RECORD OF PROCEEDINGS CONCORD TOWNSHIP BOARD OF TRUSTEES

Mr. Johnson stated the purpose of the meeting was for the Board of Trustees to consider the re-zoning application #ZC032024, recommended for conditional approval by the Concord Township Zoning Commission Board, that was filed by John Konovodoff with Maronda Homes, 5900 Wilcox Place, Dublin, OH 43016. The Applicant is requesting approval for rezoning from Farm Residential (FR-1) to Planned Residential District (PRD), and a preliminary development plan referred to as Clarkshaw Village on Bean Oller Road, parcels # 419-330-01-009-000 at 12.109+/- acres, #419-330-01-008-000 at 39.200+/- acres, and Clark Shaw Road parcel #419-330-01-016-000 at 12.110+/- acres, Delaware, OH, owned by Dulin Farms Ltd.

- The application is for rezoning of FR-1 to PRD for the project known as Clarkshaw Village on 63.63 acres with 95 lots, for a density of 1.49 units per acre, which is within the township Comprehensive Plan of 1.5 units per acre maximum.

EXHIBIT C-2

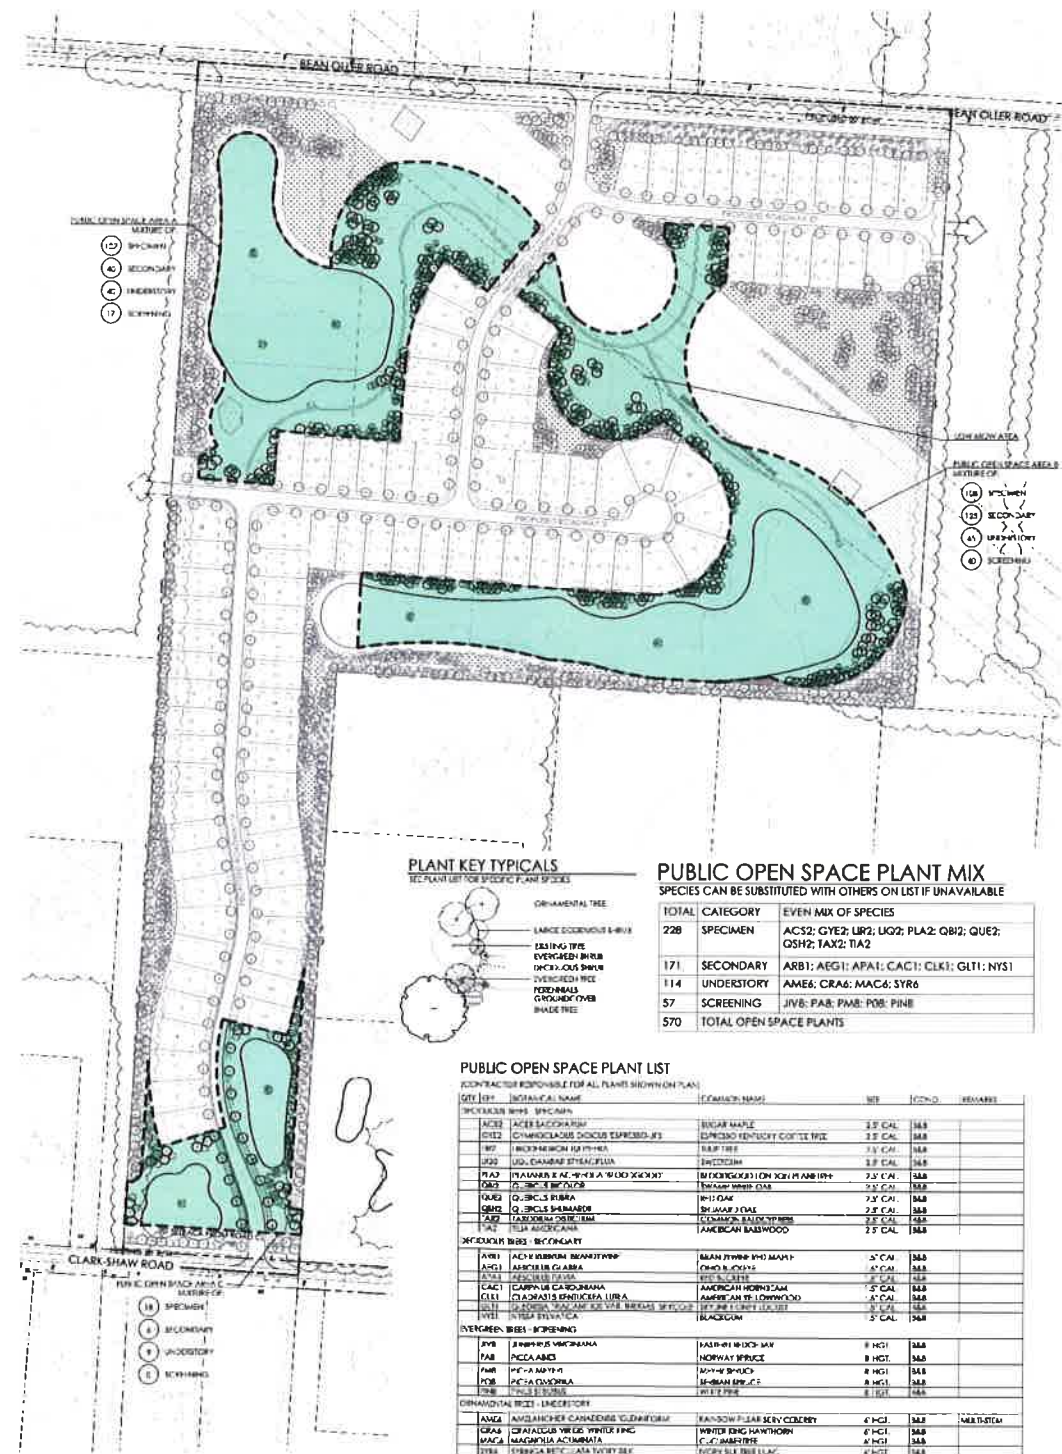
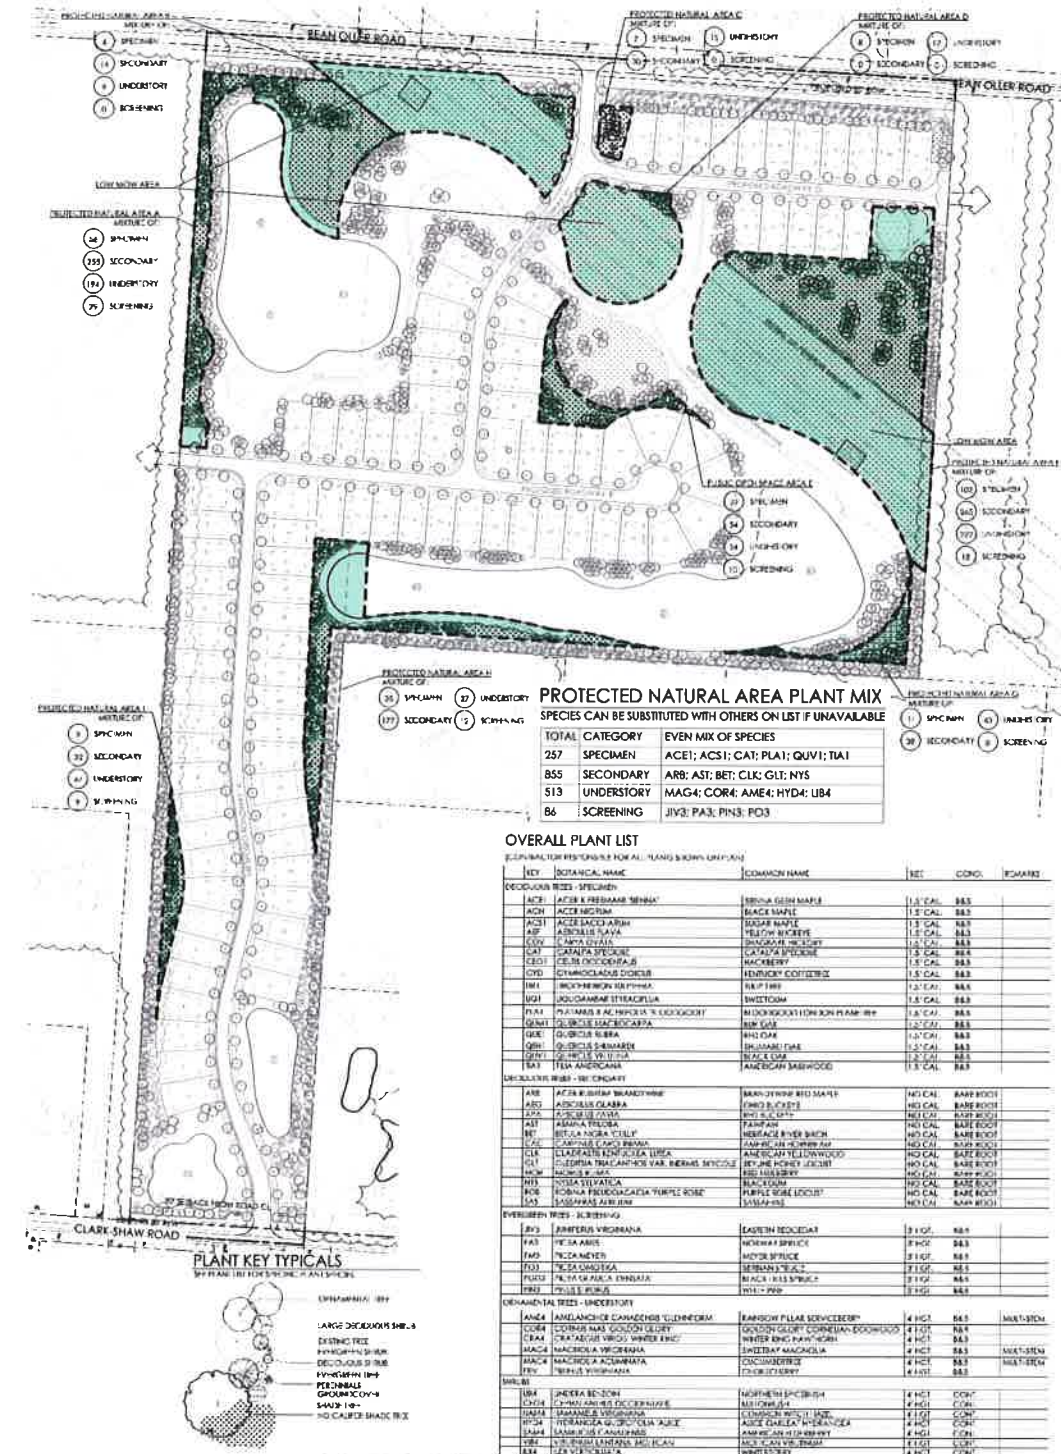
6. Address and Resolve Phase 1 construction traffic access: only to Clark Shaw Road rather than both Clark Shaw and Bean Oller Roads.
7. Provide time frame for the Development Phases.

7. Provide time frame for the Development Phases. Time frames for phasing have been added to the Phasing Plan and text.
8. Provide communication to the residents concerning construction during Development Phases. Maronda Homes has been in direct contact with concerned property owners, contact information has been exchanged, and informal meetings between the development team and the property owners.

6. Address and Resolve Phase 1 construction traffic access: only to Clark Shaw Road rather than both Clark Shaw and Bean Oller Roads. Construction entrance notes have been added to the Phasing Plan identifying construction entrance locations per phase.

ENTRY DRIVE HEADLIGHT SCREENING PLAN

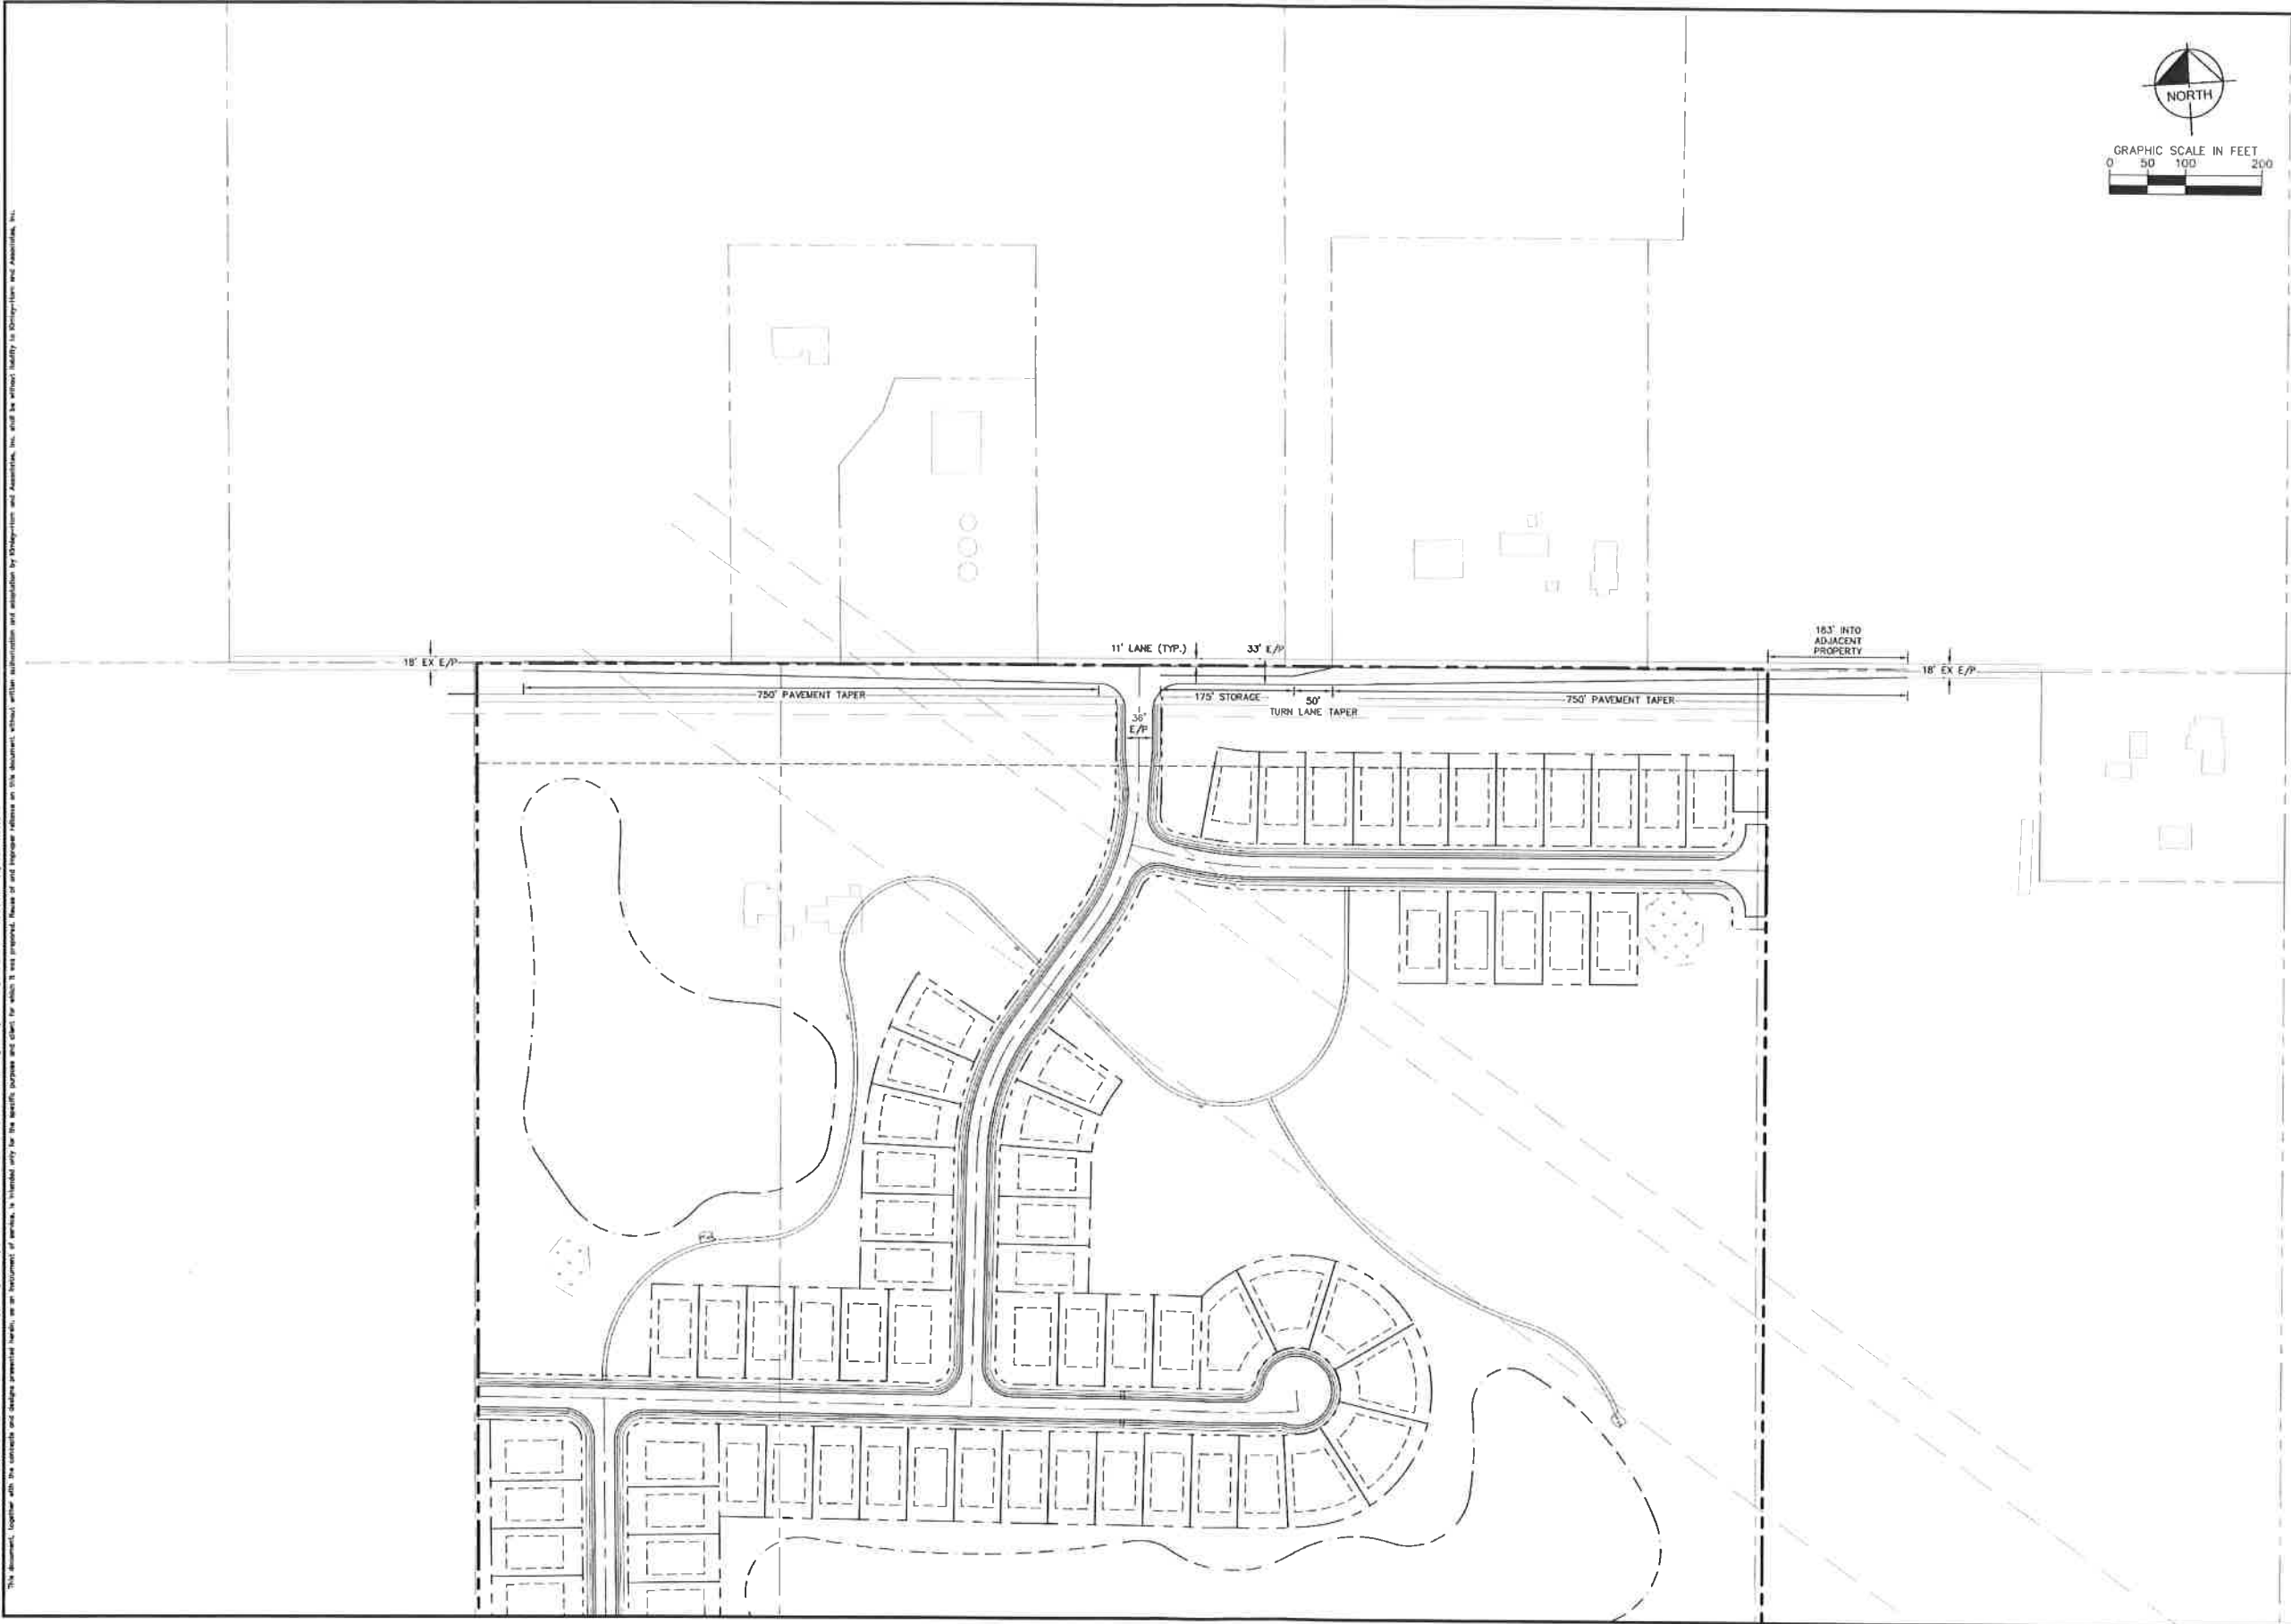
10. Headlight issues for properties across the road from the Clark Shaw entrance were addressed. The house directly across sits about 600' off the road, and headlights reach about 300'. Regardless, the owner did not want a fence or mound, so plantings are proposed. The Trustees would like the developer to also reach out to the other neighbors to the east and west to see if there are additional concerns.

10. Provide to the Trustees details for the additional mounding and buffering for 4069 Clark Shaw Road: directly across from the main entrance to prevent the headlights from shining into his house.

10. Provide to the Trustees details for the additional mounding and buffering for 4069 Clark Shaw Road: directly across from the main entrance to prevent the headlights from shining into his house. The development team has met with the property owners about their concerns. Solutions considered have been shifting of the development entrance, mounding, fencing, and screen planting. Of the alternatives, planting seems to be the most appropriate solution.

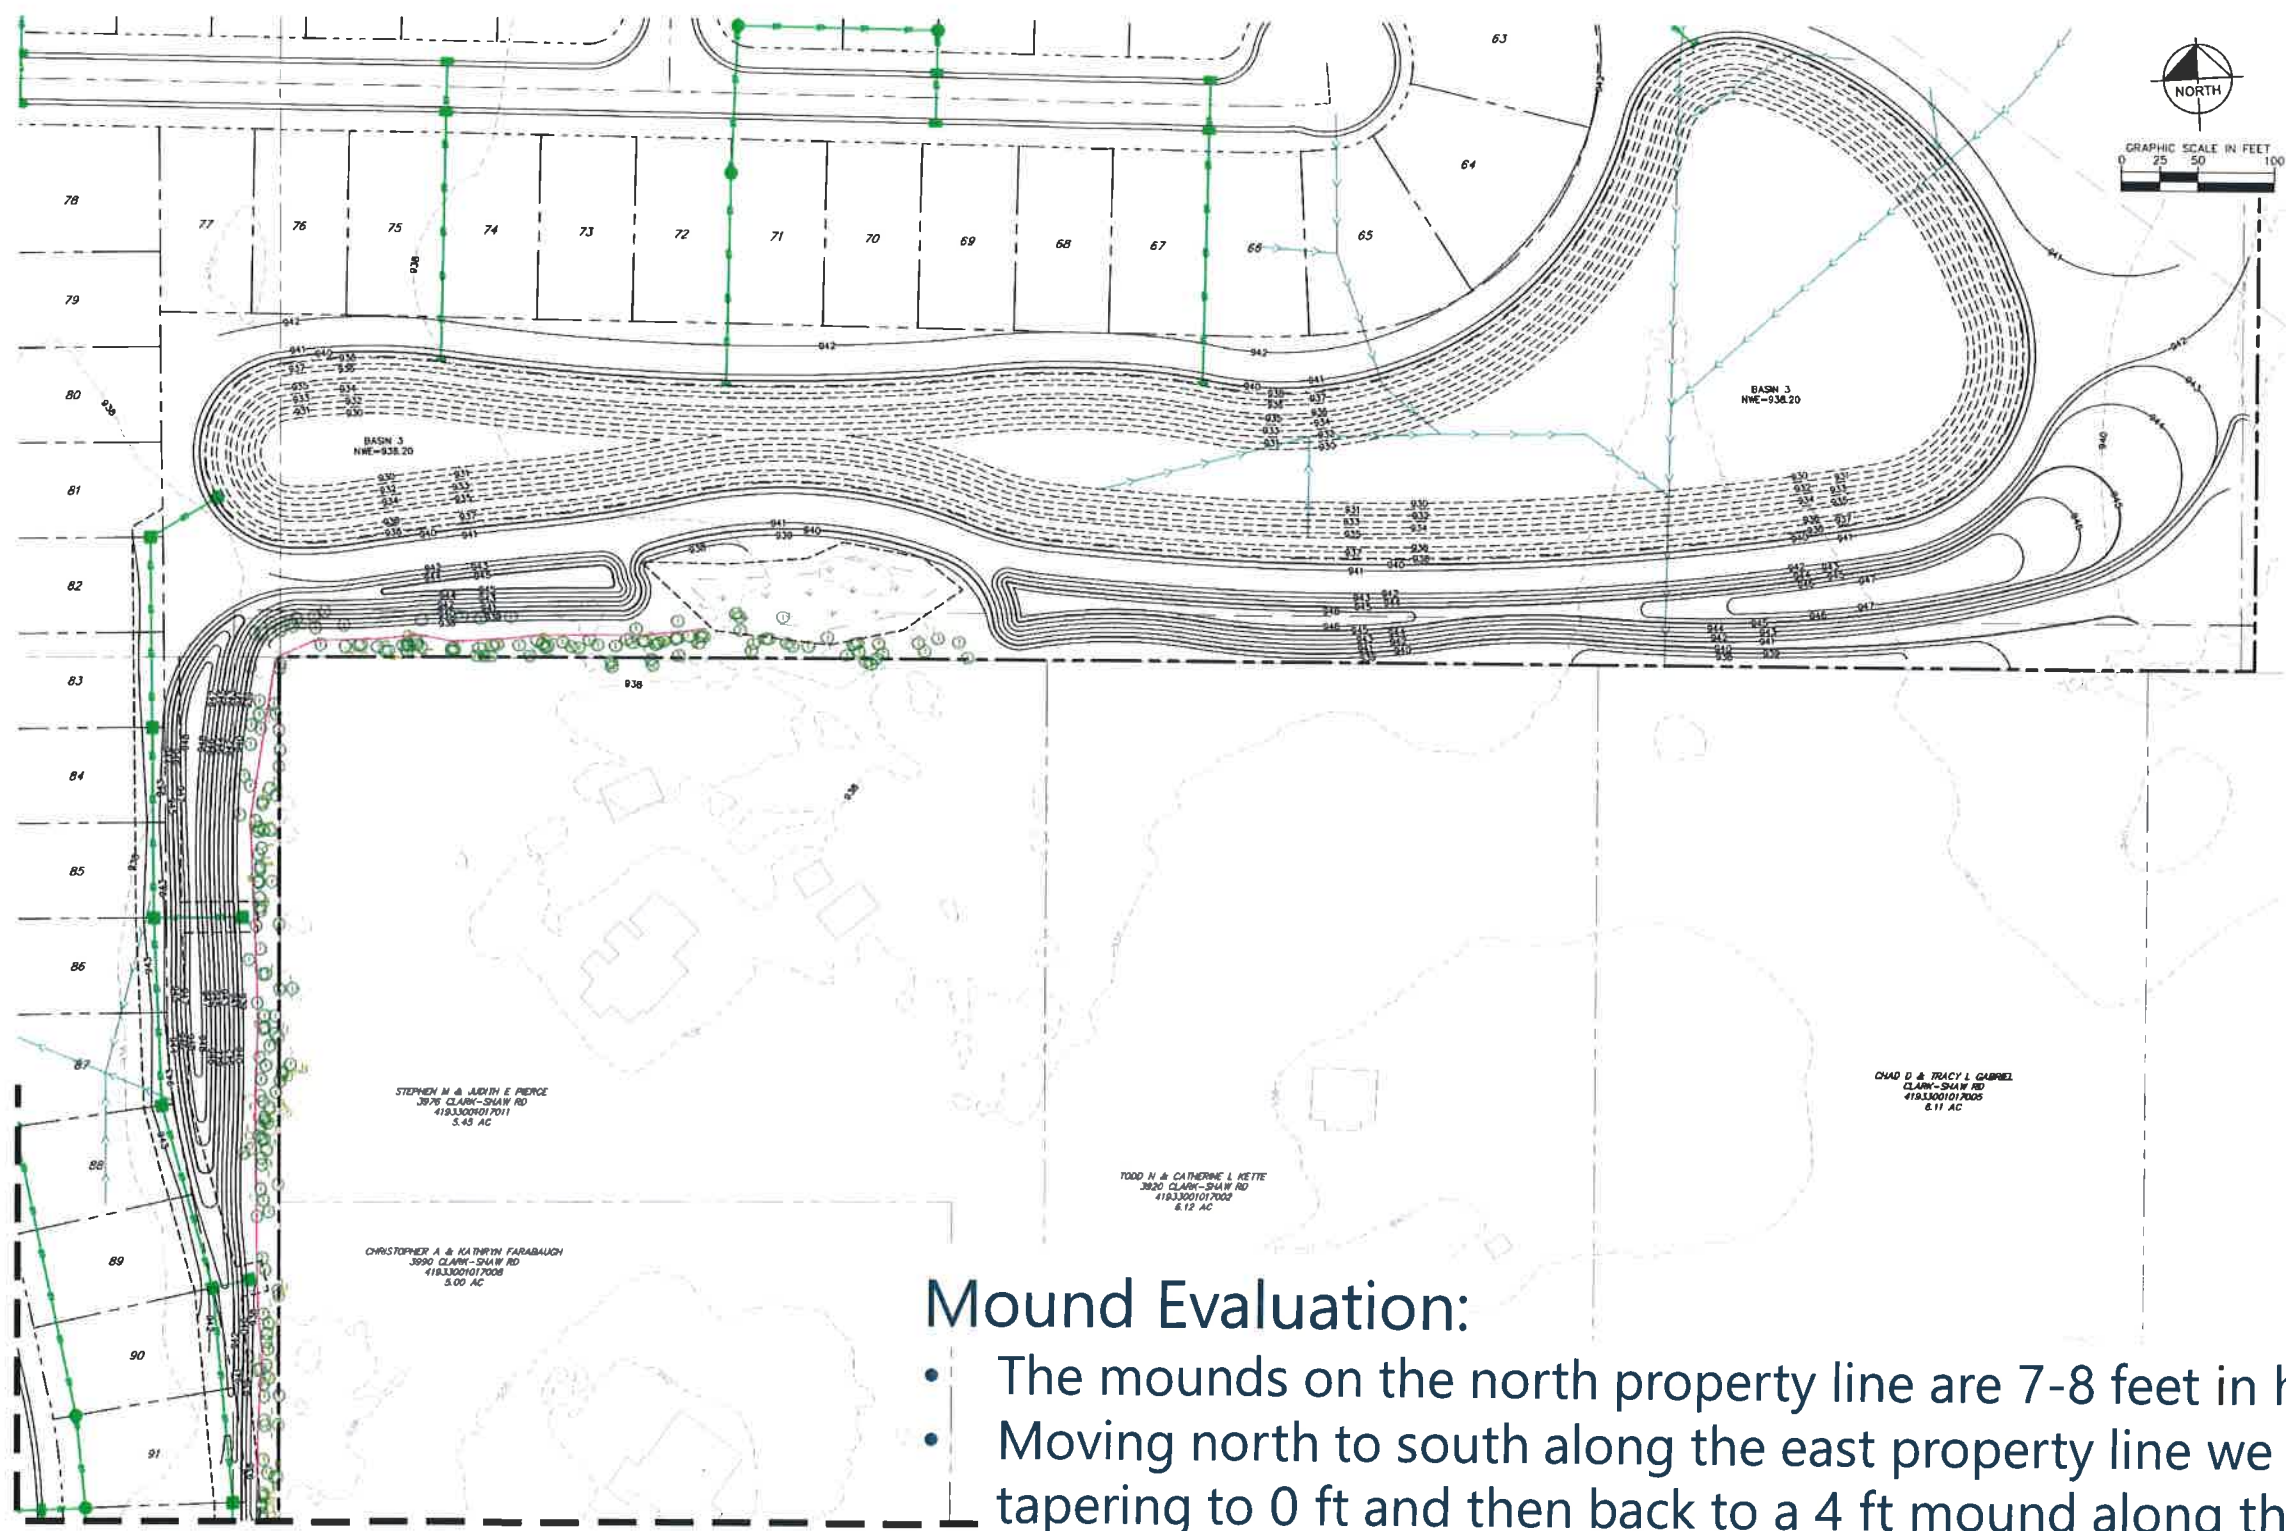
5. The left turn lane on Bean Oller Road was discussed. Scott Mincks, engineer at Kimley Horn, 7965 N High St, Columbus, said the road would be widened from 18' to 33' with a turn lane, per the Delaware County Engineer's office.

4. Provide to the Trustees a resolution for the issue of Lot 72, the driveway is in the middle of the intersection.
5. Provide to the Trustees an accurate Development Plan which includes the Bean Oller turn lane location.

5. Provide to the Trustees an accurate Development Plan which includes the Bean Oller turn lane location. **A left turn lane has been added to the site plan.**
